SI B66 15 16  
Distance Systems, Cruise Control, Remote Control

**THE SMART OPENING/CLOSING TAILGATE FUNCTION IS INOPERATIVE.**

F48 (X1) Vehicles with option code 322 (comfort access) Vehicles produced to July 6, 2016
---

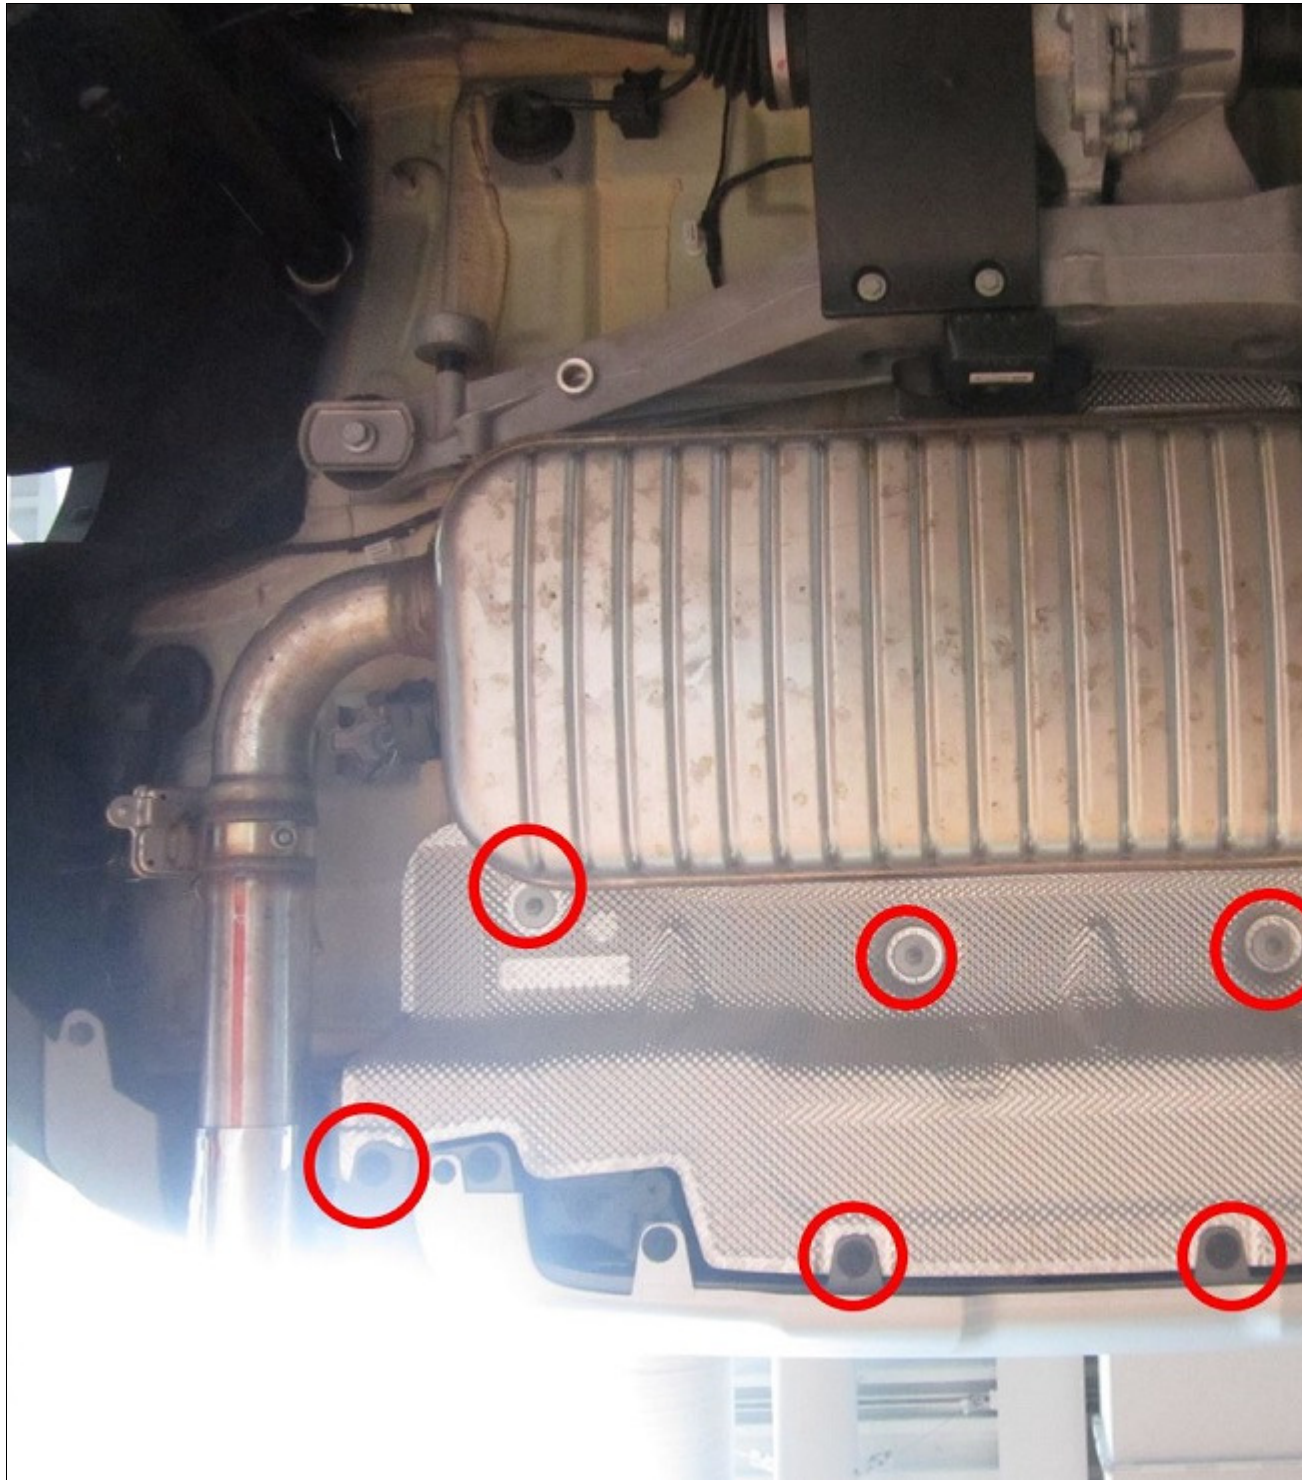
The heat insulation on the rear bumper partially blocks the top and/or bottom sensor signal, which prevents foot movement detection

Remove the heat insulation shield and cut the areas as shown in the picture below.
